Subject: Article 32: Traffic Visibility Around Corners Interpretation

Dear ARB Chair Zsembery and ARB Members:

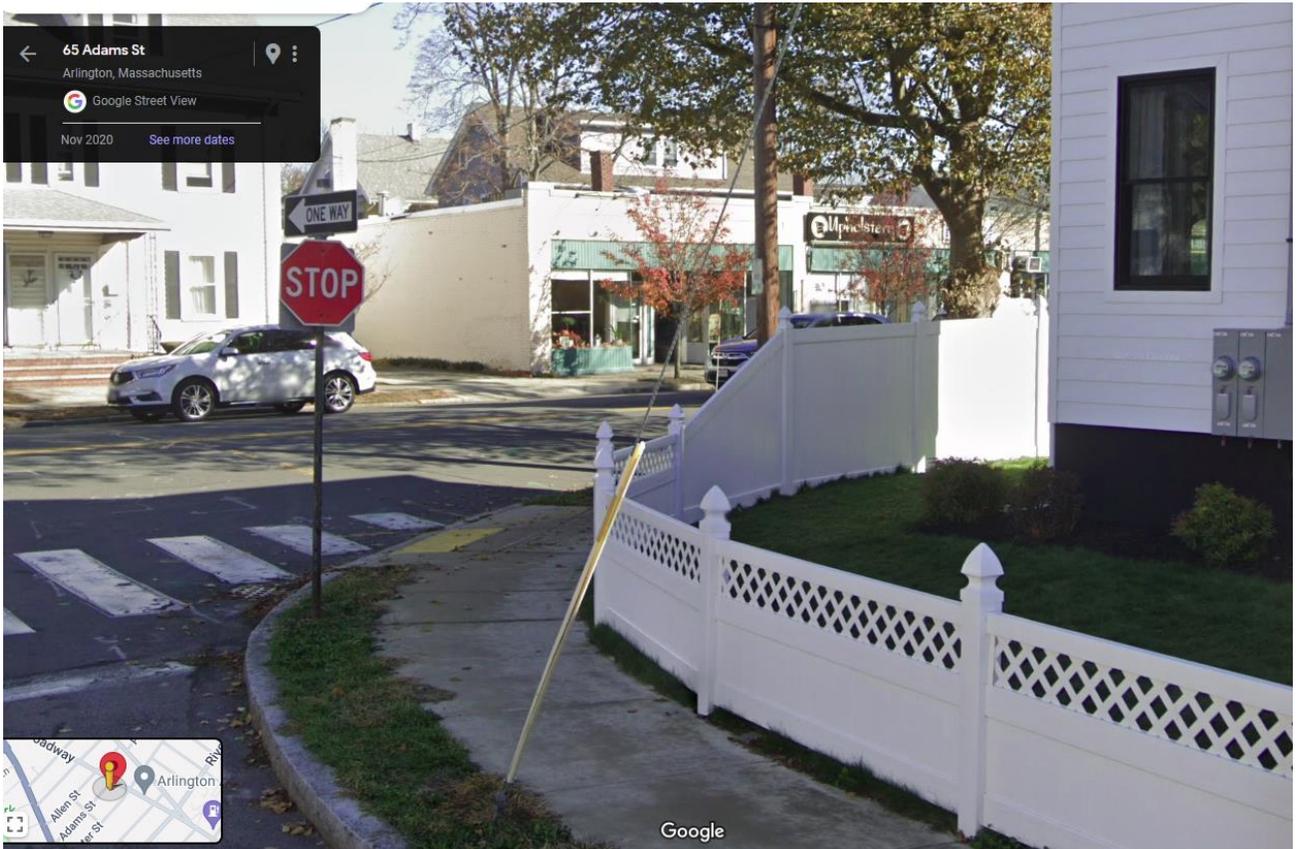
The figures below show how this section of the bylaw has been applied in practice. During the public hearing for ZBA Special Permit 3601, I asked that a hedge/chain link fence that violated this bylaw provision be remedied as part of the renovation of 210-212 Broadway--the white house in the figures. A new plastic fence approved by the Building Inspector was installed.

The front, right corner of this house is within 15 feet of the property line along Adams St. It is clear from the first photo that the higher portion of the fence (that above 3 feet) is well within 20' of the projection of this lot line. That is because it was the projected curb line, not the projection of the home's front lot lines that was used to determine compliance, just as the bylaw formerly illustrated.

Since there is typically about 8 feet between the curb line and the lot line, that means the size of the triangle shown by the proponent is much smaller--only about 72 square feet vs. 200 square feet. In short, this bylaw provision imposes a very modest burden on property owners to protect pedestrian safety.

TRAFFIC VISIBILITY ACROSS CORNERS, SECTION 6.22

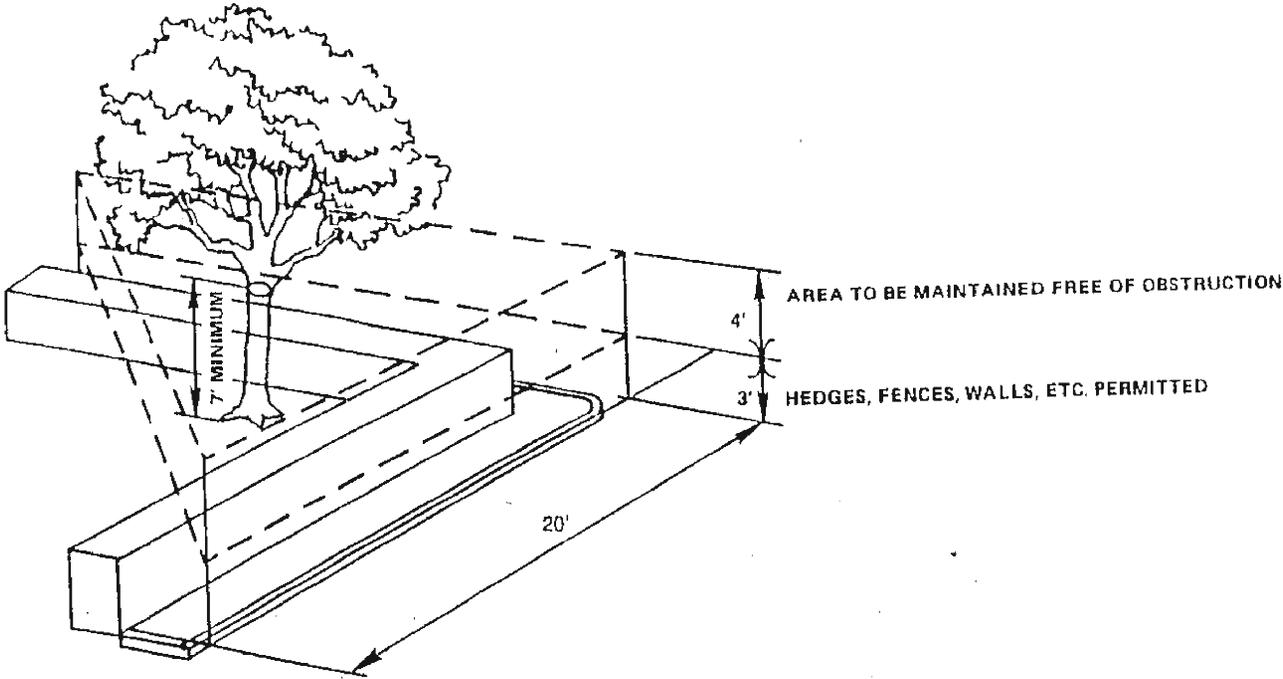
Attached to this email is a page from the 2008 printing of the Zoning Bylaw that illustrates what was then Section 6.22. The same language is now Section 5.3.12(A). Unfortunately, the town did not bother to include this illustration in the recodified zoning bylaw.

This illustration clearly shows that the 20' sides of the triangle where the height limitation applies are measured based on the intersection of the curb line, that is, where the curb meets the street ("property lines of intersecting streets") not the corner of the homeowner's lot as the proponent indicated. I believe the bylaw has been interpreted that way since at least 1975, as the 2008 edition indicates no amendments were made since then (also unfortunately, the annotations showing amendments have also been dropped from the bylaw). I do not believe any amendments have been made to this provision since 2008.
